# Jacobsen Product Information Bulletin

**Product Type: Lawnaire 28**

**Bulletin No: C-043-04**

## Tine Arm Welds

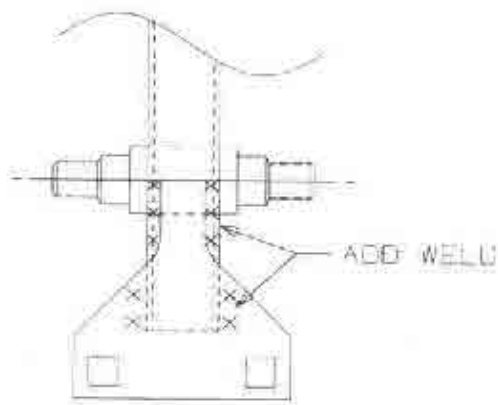
It has come to our attention that part number 547509.7 might be welded incorrectly.

Need to inspect part number 547509.7 to see that the tine arm is welded as shown. If not you will need to have the tine arm welded on both sides at the "x".
